# 18-22 Haverstock Hill Section 96a Design Statement

This design statement has been produced in support of a S96a application for minor design amendments to the commercial unit and a limited number of the external openings as a result of detailed design development undertaken by the consultant team. In line with the objective of providing high quality housing and retail space the proposed plans propose the following revisions:

Proposed Front Elevation

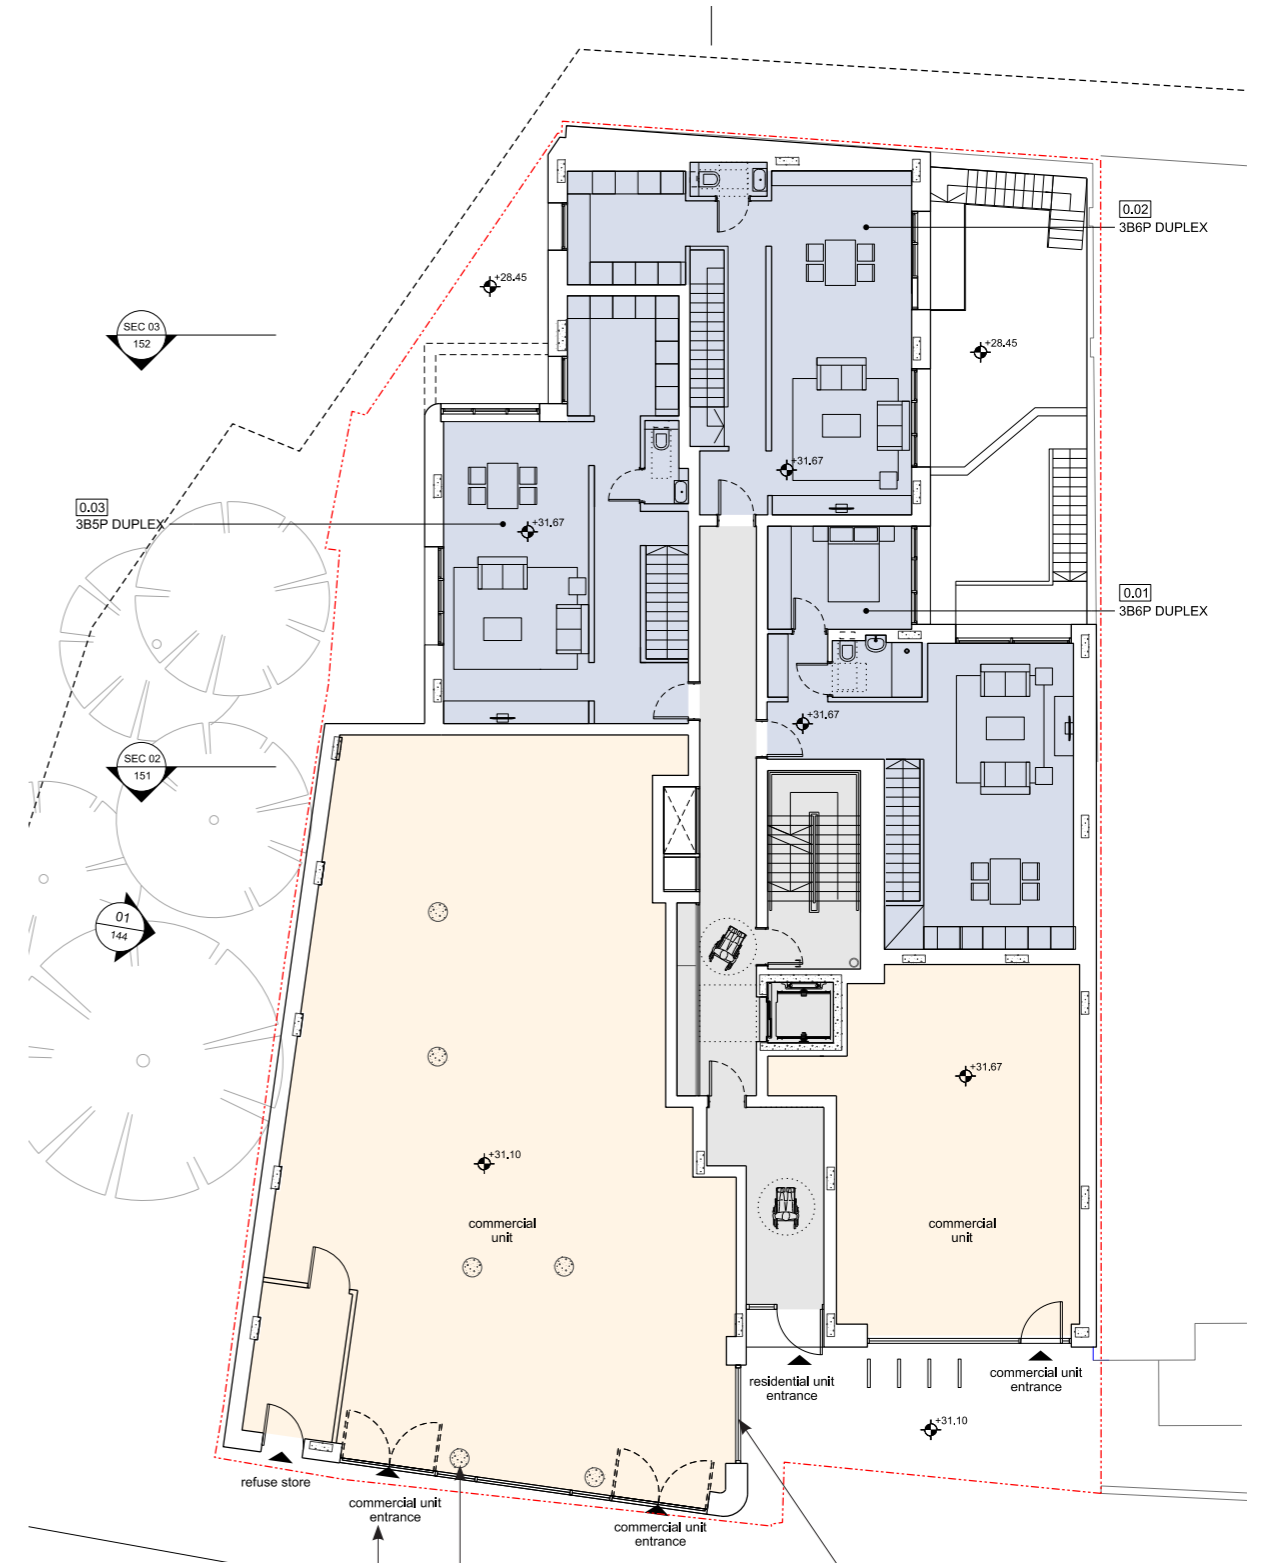
- The continuation of the small convex brickwork corner down to ground level to provide a robust and authentic 'grounding' of the building. The previously consented glazed corner to the commercial unit requires several structural beams to be introduced (see following page) and the radius of the glazing would not match the tight radius of the brickwork above. The proposed solid corner aligns with the openings on the upper floors and is of the same width as the adjacent brickwork piers. This helps to create a more cohesive and rhythmic front elevation.

- The arrangement of the commercial shop front glazing and mullions has been adjusted so that the vertical elements align with the upper floor openings. A second door-set is provided to the commercial unit in order to comply with fire escape requirements. The circular columns within the commercial unit are located directly behind the fixed glazing panels, visually demonstrating the structural integrity of the building.

- A discreet opening is introduced to provide access to the proposed commercial refuse store. See page 6.

Glazing bars and structure align with brick piers above

Brick corner introduced. The width of the pier matches the width of adjacent brickwork providing a solid, authentic grounding to the building.

Commercial columns are aligned with shop front glazing and glazed elements above

Fire rated glass protecting the escape for residents is terminated neatly at the brickwork corner

Secondary means of escape provides symmetry between columns

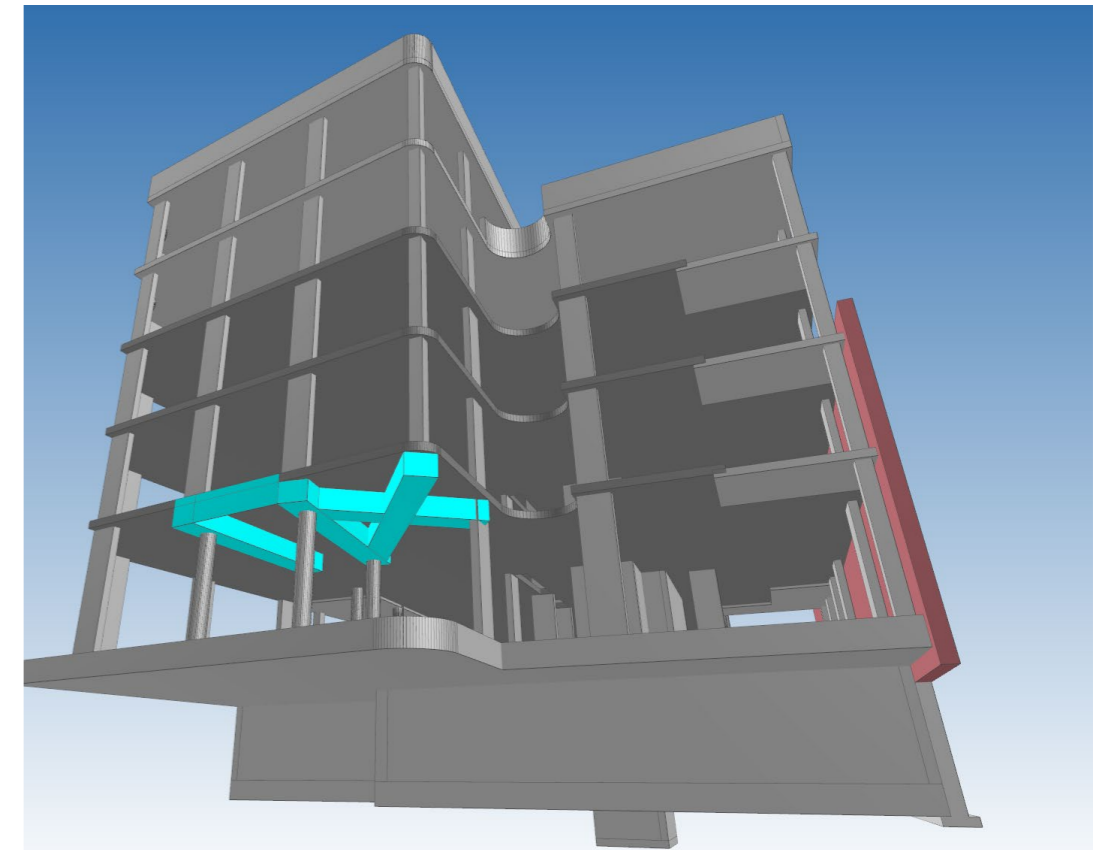
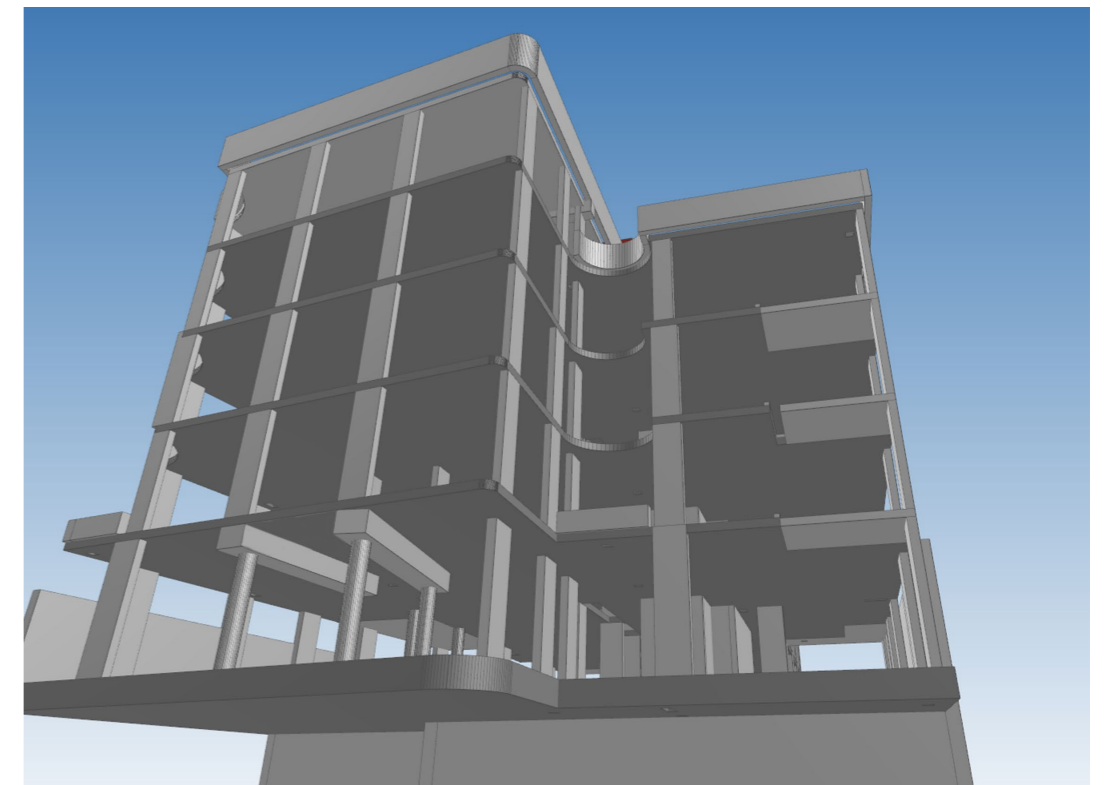
The 3D images on this page demonstrate the different structural solutions required to achieve the proposed and consented schemes. To achieve the curved glass corner several 800mm deep down stand beams would be required to transfer the loads. This would make the commercial soffit to the front elevation unusable and potentially compromise the top spandrel panels to the shop-fronts.

Bringing the brickwork down to ground level simplifies the structure, providing a clean soffit that will not interrupt the glazing lines whilst allowing the tenant to utilise the soffit of the ceiling for necessary services, lighting and architectural coverings. The structural and architectural solutions are more cohesive and this is reflected in the revised elevation where the structural authenticity is clear.

Consented- Structural offsets and down-stands required to achieve the existing glazed corner

Proposed - Brickwork corner allows a column to be introduced to simplify the structure. Form follows function in a rational, elegant manner.

Consented Ground Floor Plan - Changes requested by the Fire consultant to make scheme compliant

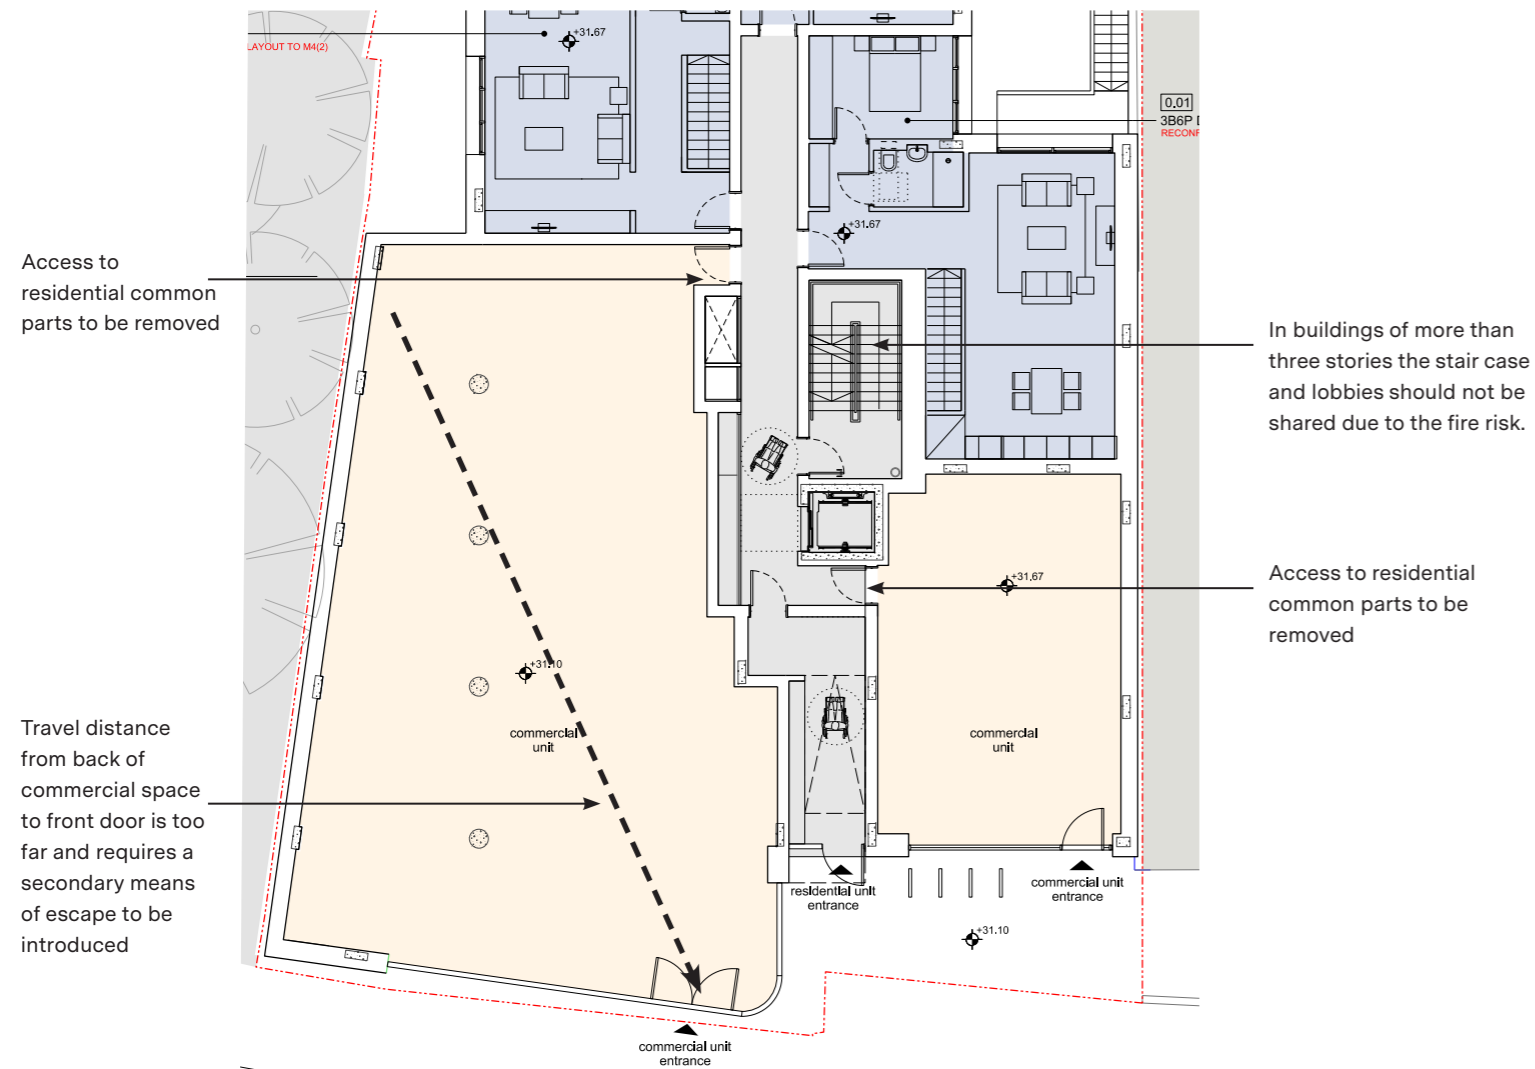
The consented layout for the ground floor commercial units included rear service doors providing commercial tenants with access to the shared staircase and basement refuse store.

MLM Building Control and MLM Fire consultants have advised that the consented layout for the commercial basement access would not comply with the Building Regulations and BS 9991.

BS 9991 states that in mixed use developments, in buildings having more than three stories, the stair case and lobbies should not be shared so as not to create a fire risk.

The consultant team have reviewed the available options and concluded that the best and most viable solution is to sensitively relocate the commercial refuse storage to the ground floor to provide direct access from the street.

The design of the front elevation has been developed to sensitively integrate an access door which is consistent with the ground floor elevation at street level. The high-quality, secure metal clad door is positioned to be aligned with the edge of the brickwork above so that the door is unobtrusive and makes a positive contribution to the rhythm of the façade.

Proposed Ground Floor Plan demonstrating how the development is now compliant with fire regulations.
